Re; Application for Waste Licence (W082-02) Greenstar, Dock Road, Limerick

I refer to the Agency's letter dated the 26th May 2014 in accordance with Regulation 10(2)(b)(ii) of the EPA (Industrial Emissions)(Licensing) Regulations 2013. The requested information is set out herein.

Figure 1

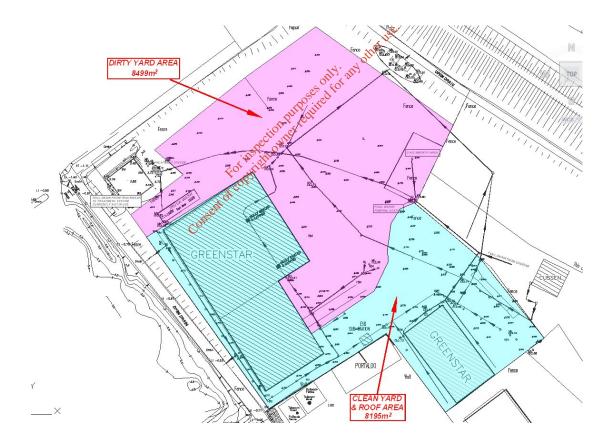
As described in Attachment I. 2 of the Application, the monitoring of the run-off from the paved area has identified elevated Biochemical Oxygen Demand (BOD) and suspended solids. To address this issue, it is proposed to divide the site into 'clean' and 'dirty' areas in terms of surface water run-off management.

The 'clean' area will comprise the building roofs and the yard in the south east of the site (8,195m²), while the 'dirty' area will comprise the yard between the processing buildings and the northern and north eastern boundaries (8,499m²).

The areas are shown on Figure 1 in the IE Consulting Report in Attachment D1 of the Application. A copy of the report is in Attachment 6. The 'dirty area' will include the MSW baled storage area, the metals, wood, C&D storage bays and the baled plastic and paper and cardboard storage areas.

Figure 1 below illustrates a delineation and segregation of clean yard and roof run-off areas and potentially polluted areas that have the potential to generate trade effluent. The below segregation of clean and potentially polluted areas can be achieved by undertaking minor alterations and re-routing to the drainage system within the boundary of the site.

As illustrated in *Figure 1* above the clean yard and roof area is approximately 8195m² and the potentially polluted yard area is approximately 8499m². Considering a permeability co-efficient of 0.85 for concrete hardstanding areas, the effective potentially polluted yard area is approximately 7224m².
